Access Compliance Report

Public Rights-of-Way

(Curb Ramps)

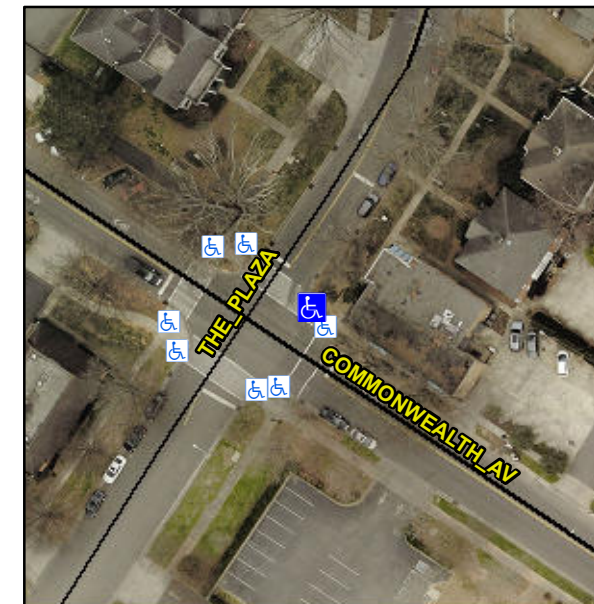
Intersection ID: 13408	Main Street: COMMONWEALTH_AV	Cross Street: THE_PLAZA	Location: E
ADA ID: 3F0EAFEB1690	Ramp Type: Directional1	Initial Pass/Fail: Fail	Overall Compliance: No
Severity Score: 1.25			
Codes/Mitigation Info/Possible Solution		Field Measurements/Component Compliance

R304.5.3

Remove & Replace Entire Ramp.
